## **Access Compliance Report Public Rights-of-Way** (Curb Ramps)

Intersection ID: 43886 Main Street: ABBOTT ST Cross Street: W\_WORTHINGTON\_AV Location: SW ADA ID: FB41E5595320 Ramp Type: Directional1 Initial Pass/Fail: Fail **Overall Compliance: No Severity Score:** 1.25

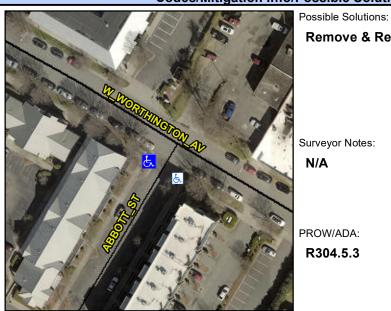
Remove & Replace Entire Ramp. Surveyor Notes: N/A PROW/ADA: R304.5.3
